Zone disablements for Loop Input/Output devices

Hochiki specific revisions:

Argus Vega specific revisions:

Option to include/exclude module inputs / outputs in the module zone disablement

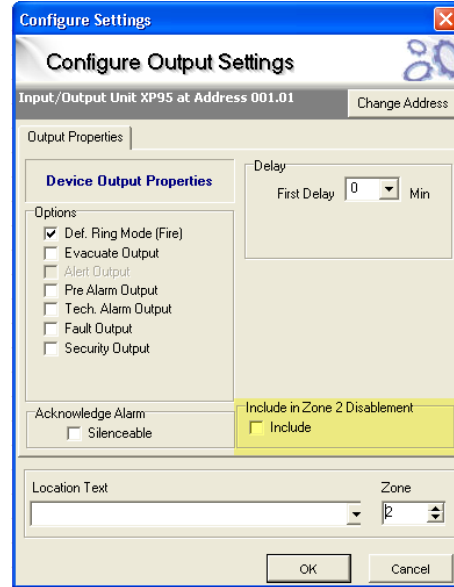
It is now possible to configure a loop I/O device so that when the physical module address and input / output addresses are mapped to different zones, there is an option to configure whether all sub-address inputs/outputs will be disabled with the zone of the module or not.

Option to include inputs in the module zone disablement

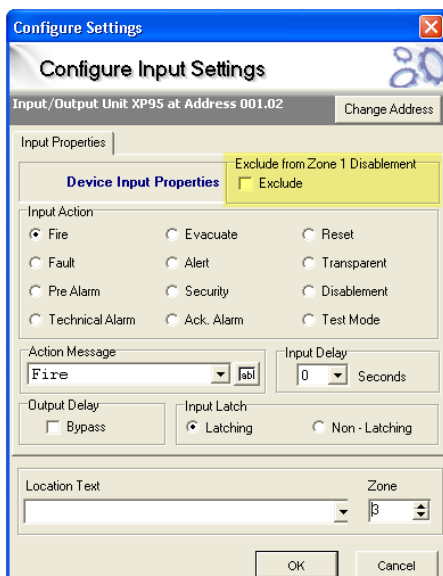
Option to include output sub-addresses in the zone disablement to which they are configured

When a zone is disabled, normally only input devices are included in the disablement and outputs remain active. We have added an option to permit I/O outputs to be included in the zone disablement to which they are configured

Finally, if the Inputs/ Outputs are configured to be included in the module zone disablement (as shown above) and the inputs are configured to different zones to the module address zone, they can still be included / excluded in the module zone disablement.

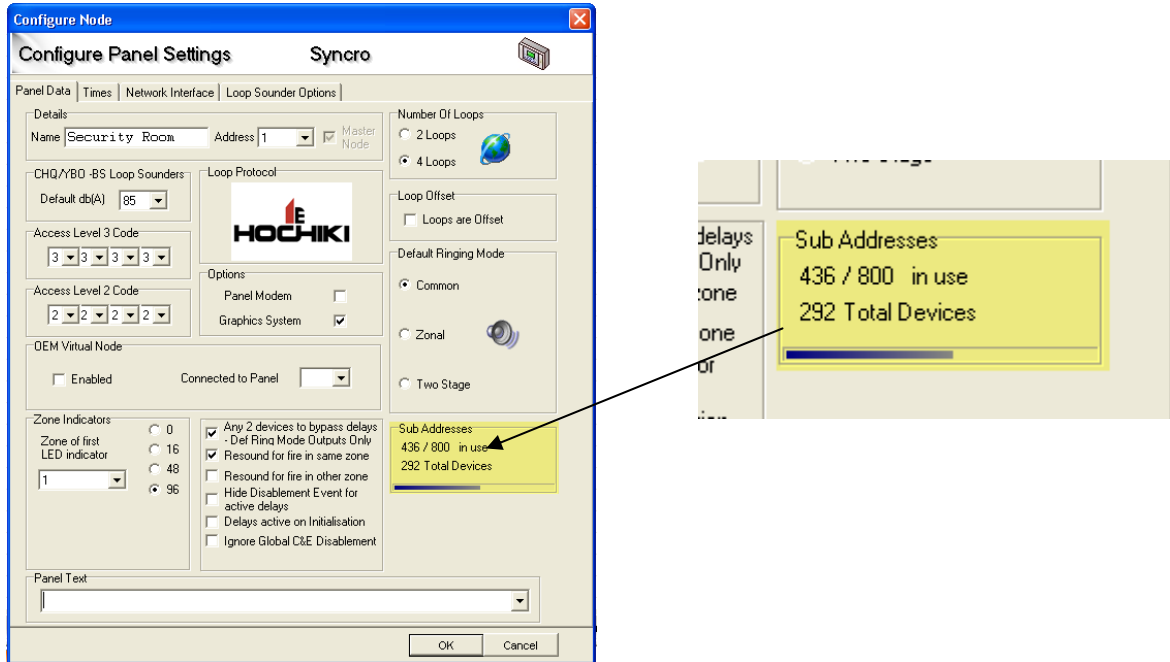
Adding these levels of flexibility allows simple isolation of all plant control outputs / inputs by means of a single zone disablement, rather than by complex cause and effects or macros.

Many customers used to map all plant outputs to Zone 500 and disable that zone to make the system safe for them to work on the system, but this option was removed for EN54-2 approval in V5.xx versions.

We have partially re-instated this facility using these configuration options

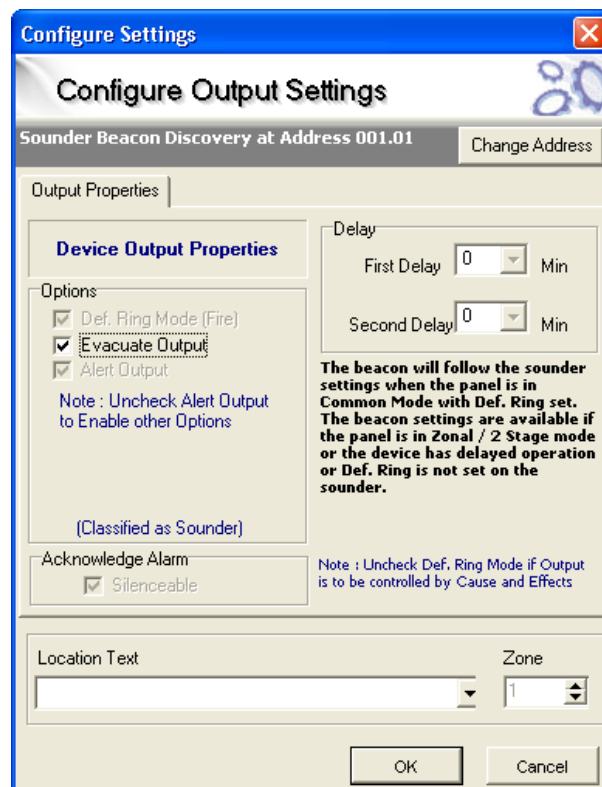
The revised tone selection screen allows DSBB tone options and priorities supported by the devices to be clearly represented and configured.

The "common event" tones (tones that are sent to all DSBB regardless of the source of the event) have higher priority than "direct" commands to the DSBB.

Direct commands then use the 15 Apollo tone pairs for the tone selection. "Evacuate" or "Continuous Cause and Effect" outputs will use the DSBB primary tone, "Alert" or "Intermittent Cause and Effect" outputs use the secondary tone from the selected pair.

CHQ-POM configuration screen

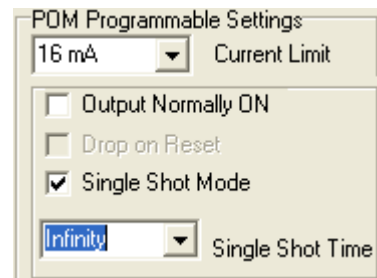
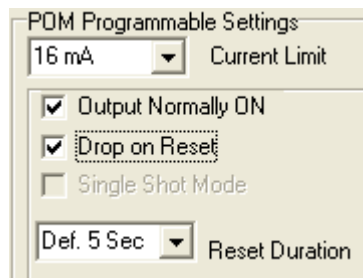
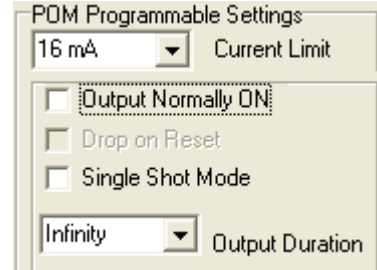
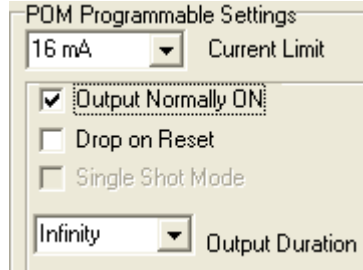
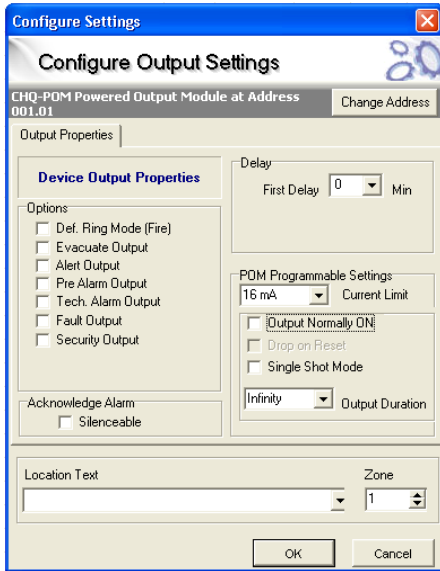
The configuration options for the POM output has been tidied to simplify the device settings and only allow the combination of output attributes supported by the device to be configured
